APPENDED HEALTH AND SAFETY PLAN FOR TASK ORDER 1

RCRA Facility Investigation/Corrective Measures Study (RFI/CMS) and Base Closure Environmental Study for the Lexington-Blue Grass Army Depot

Contract No. DAAA15-90-D-0016
Task Order Number 4

October 24, 1991

Figure
3-1

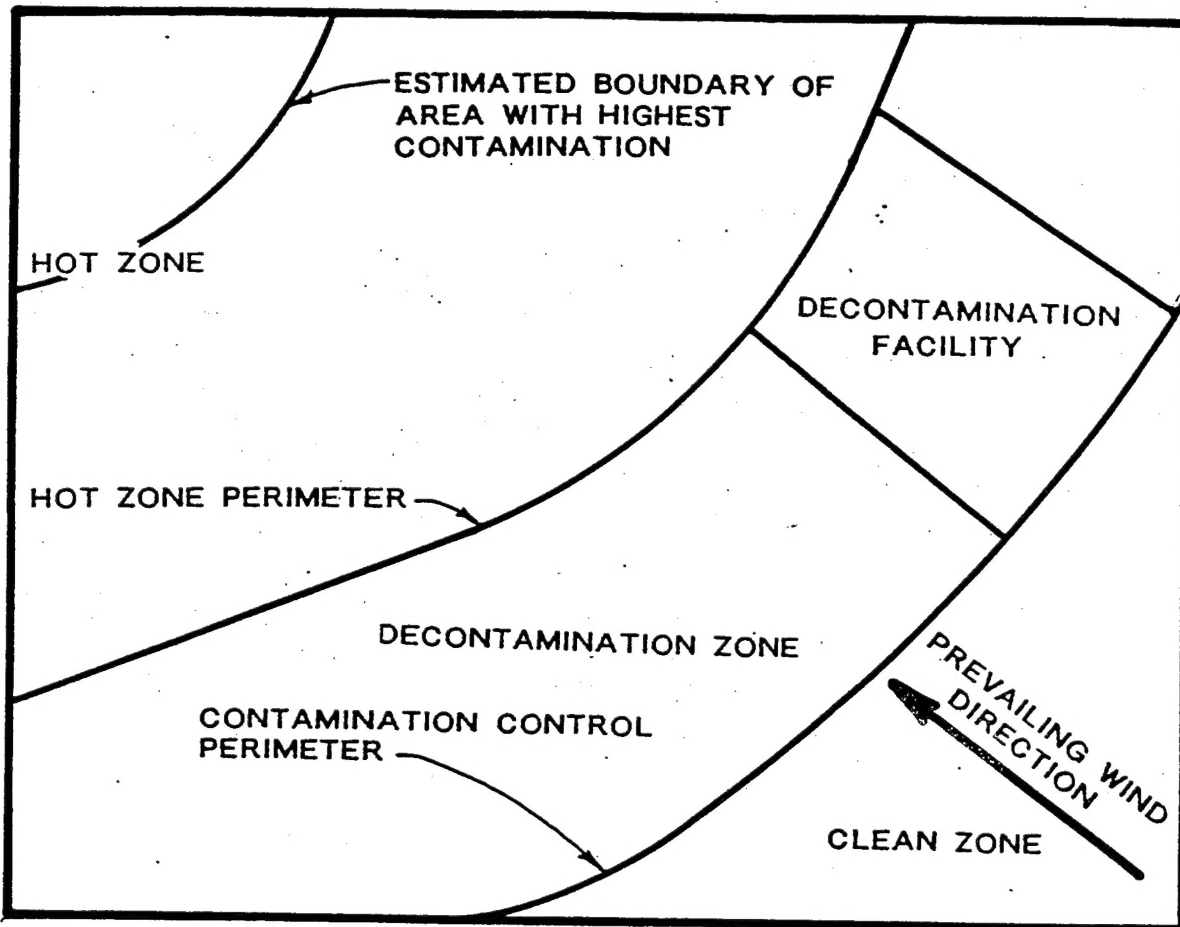
Change: Insert "Figure 3-1 is an example of Work Zone Designation" as the 3rd Paragraph.

Change: Insert Figures 3-1 and 3-2.

Figure
 3-2

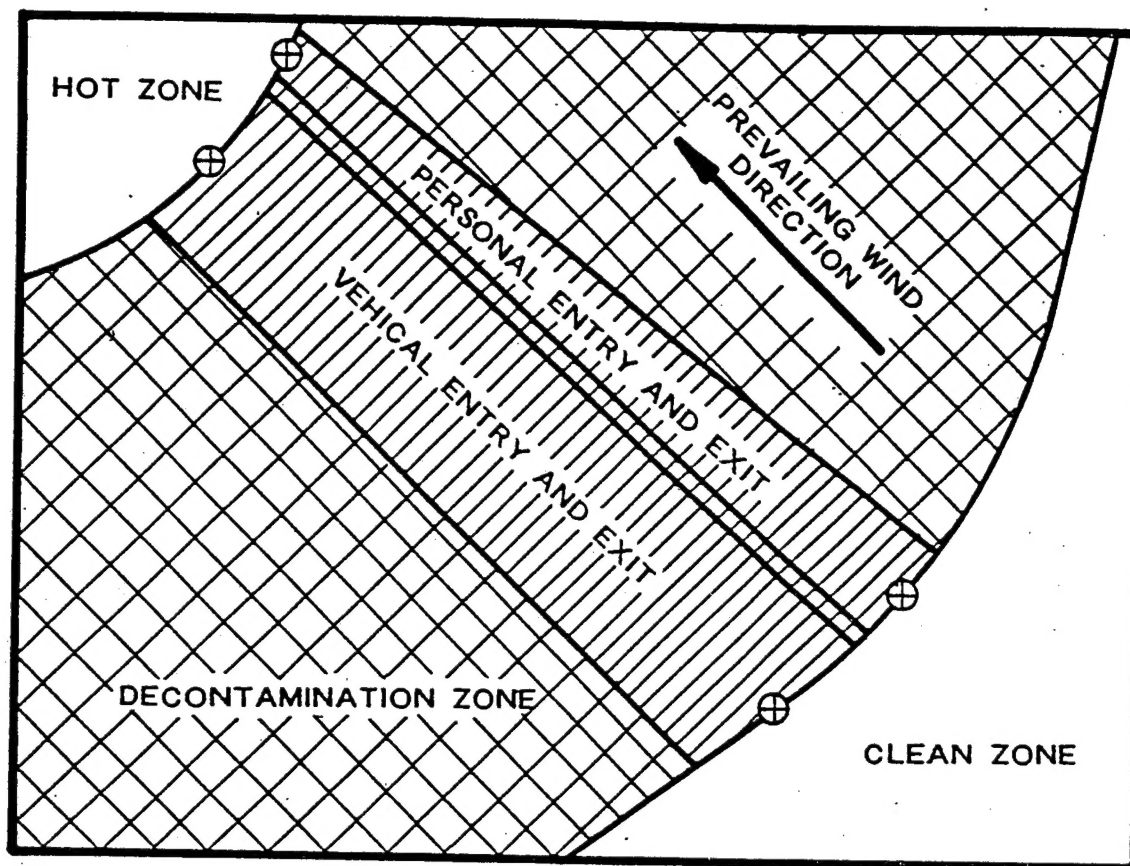
Change: Insert "Figure 3-2 is an example of a Contamination Reduction Zone" after the 8th Paragraph.
